The following is an ECO for the T100S power supply for better reliability. T100S Power Supply Mod
Parts kits are available from ADA.

T100S POWER SUPPLY MODIFICATION

ENGINEERING CHANGE REQUEST ECD # 8808
TITLE T100s negative regulator fix

ENGINEERING CHANGE REQUEST ECO # 8798 A
TITLE T1003 BIG FIX

T100S TUBE PCB P.N. 680078 Rev B 1989

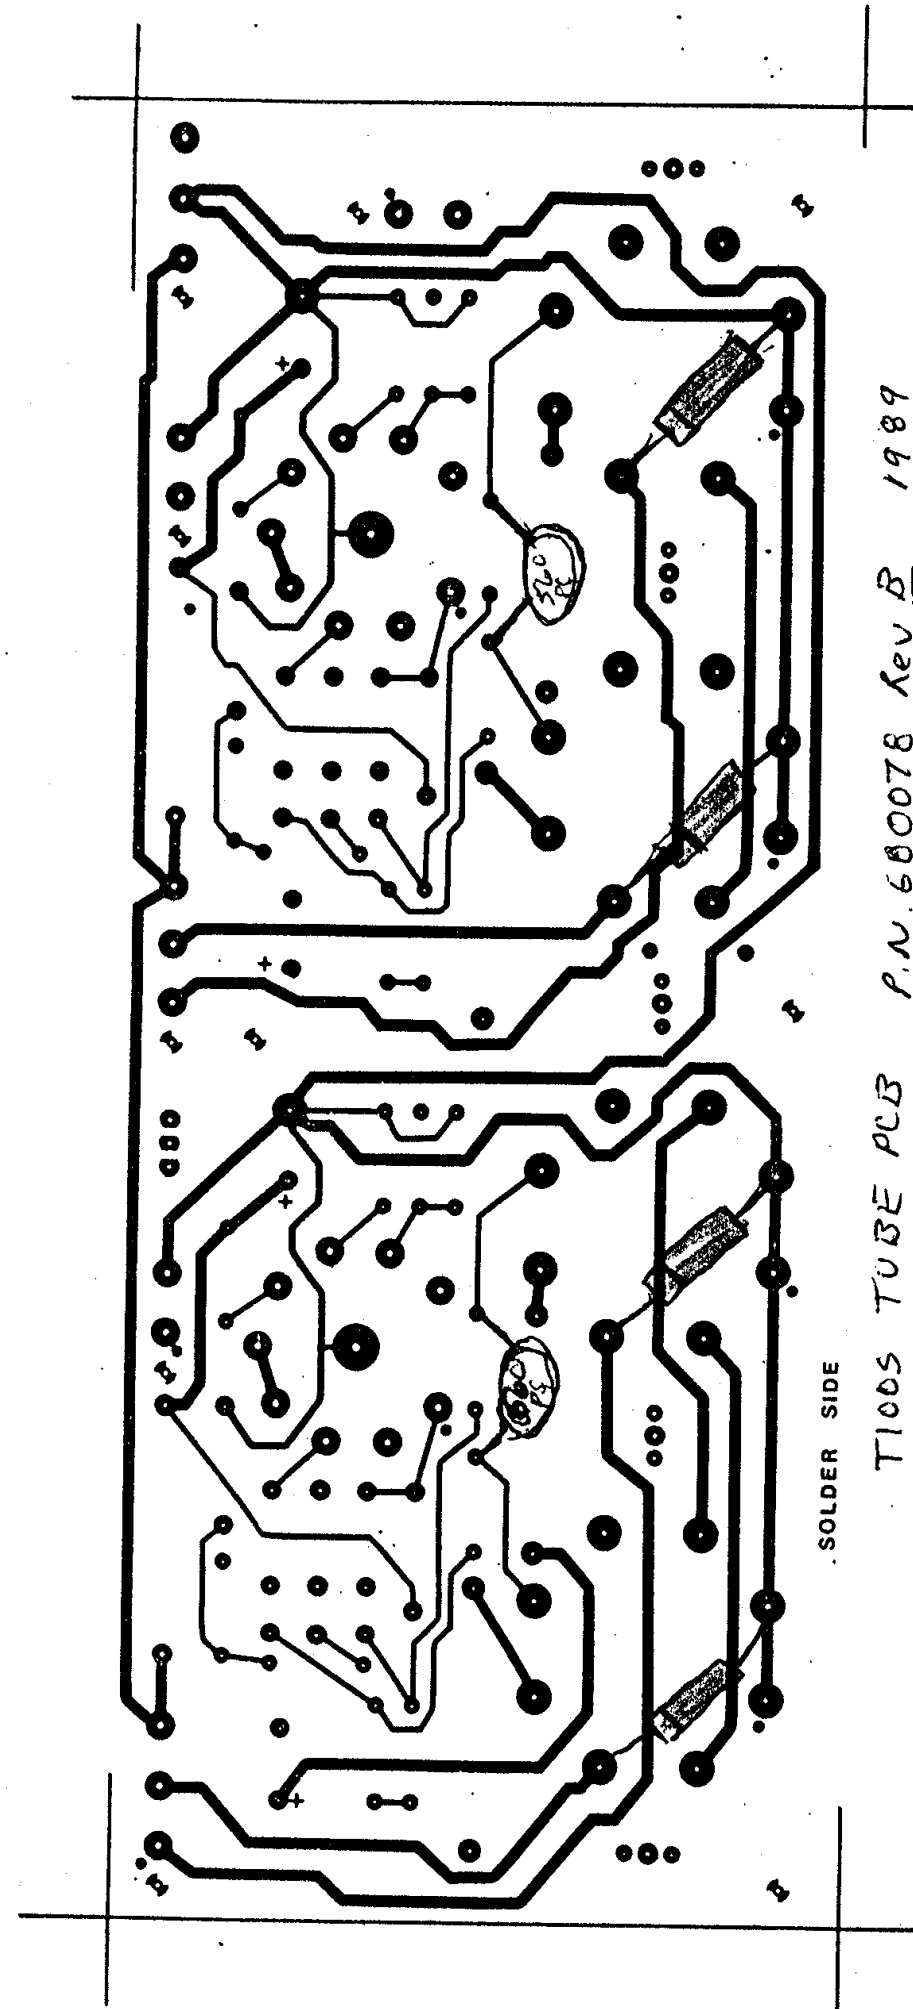
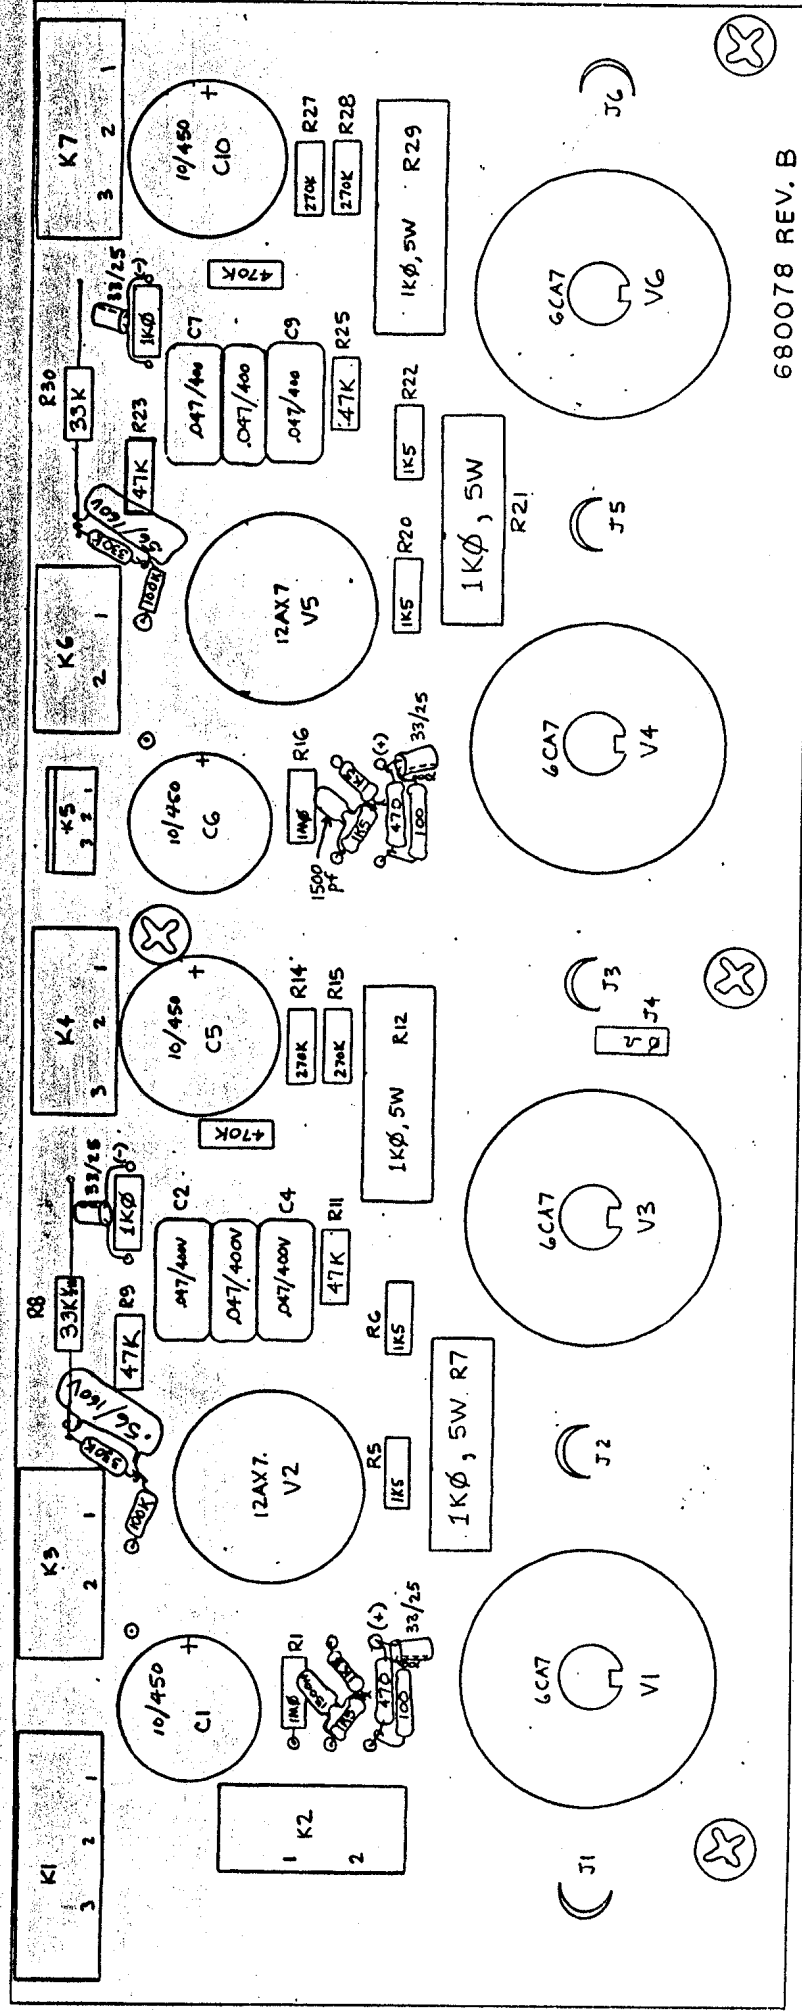
Power supply unprotected from fly back effect
of output X-fmr. Amplifier has excessive
high frequency response.

CH GEISL: 1) INSTALL EK500 DIODES, OR EQUIVALENT, FROM PLATES OF OUTPUT TUBE
TO GROUND. CATHODE TO PLATE, PIN 3, ANODE TO GROUND, PIN 8. 4 PER BOARD.
V1, V3, V4, V6.
2) CHANGE VALUE OF OUTPUT TUBE INPUT GRID RESISTORS TO 10K Ω .
4, (FOUR), PER BOARD. R5, R6, R20, R22.
3) ADD 560 P.F. CAPS. BETWEEN GRIDS OF TWO OUTPUT TUBES. CAP.
CONNECTS TO RESISTORS GOING TO GRIDS. V1 PIN 5 AND V3 PIN 5, V4 PIN 5 AND V6 PIN 5.
TWO PER BOARD.

Add (2) 560 P.F. Caps
P.N. 088080

Add (4) Diodes P.N. 100025
RK300B

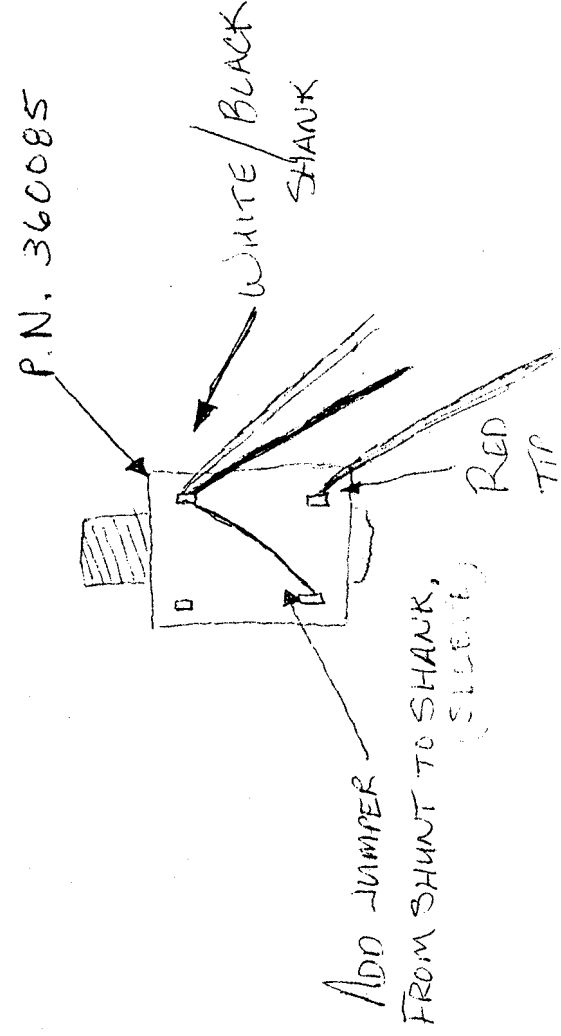
* SEE ATTACHED SHEET FOR JUMPERED OUT PUT JACK:

* Jumped output jacks.
